# Service Bulletin

**FRONT SEAT BACK TRIM SEAMS COMING APART - (LEATHER SEATS ONLY)**

**Bulletin No:** 09-025/13

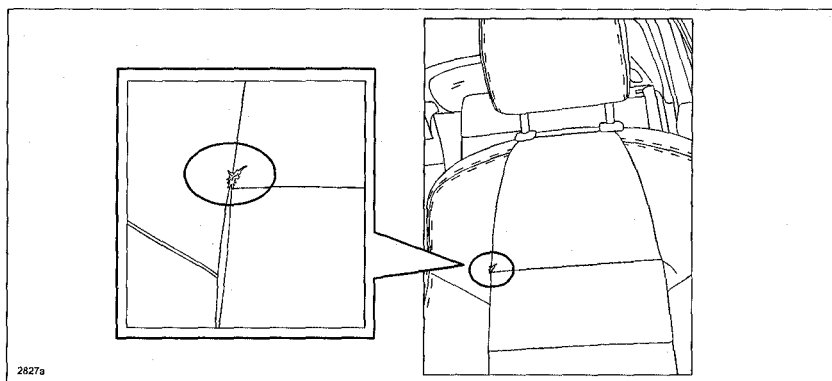
Some vehicles may exhibit a condition where the front seat back trim is coming apart at the seams. This condition is caused by insufficient sewing strength in the seams. The sewing method has been improved to eliminate this concern.

1. Verify the customer concern.
2. Replace the seat back trim with modified service parts according to the on-line instructions on MS3 or the Workshop Manual (section 09-13 FRONT SEAT BACK TRIM REMOVAL/INSTALLATION).
3. Verify the repair.
